Addendum XXX: Regulation No. LDWS+1

UNIFORM PROVISIONS CONCERNING THE APPROVAL OF MOTOR VEHICLES WITH REGARD TO THE LANE DEPARTURE WARNING SYSTEM

Regulation No. LDWS

- 2.7. “Rate of departure” means the subject vehicle’s approach velocity at a right angle to the lane boundary at the warning issue point.
- 2.8. “Latest warning line” means the outermost limit of the warning threshold.
- 2.11. Explanatory schemes

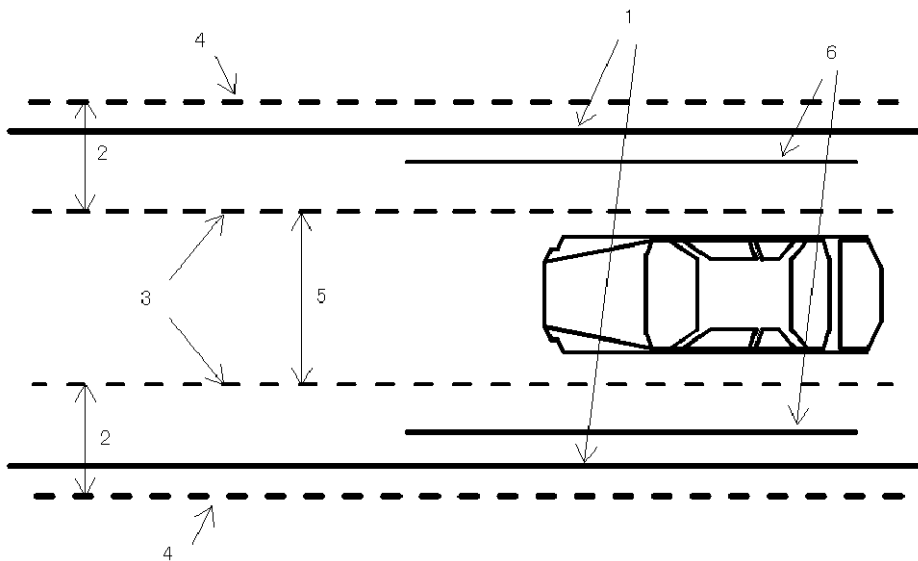
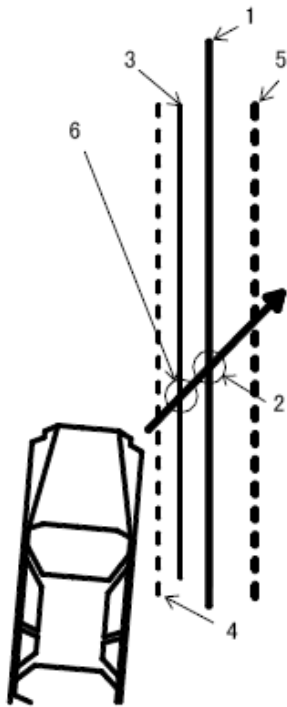
- 2.4. “Lane” means the area of roadway that a vehicle would be expected to travel along in the absence of any obstruction without the driver’s desire to change the path of travel.
- 2.5. “Visible lane marking” means delineators intentionally placed on the borderline of the lane that are directly visible by the driver while driving (e.g. not covered by snow, etc.).
- 2.6. “Lane boundary” means the borderline of the lane that is determined by a visible lane marking ~~and in the absence of a visible lane marking by incidental visible road features or other means such as GPS, electromagnetic nails, etc. In the case of a visible lane marking, the boundary shall be at the centre thereof.~~

Justification:

Considering the current road station, it is not necessary to mention such a special case.
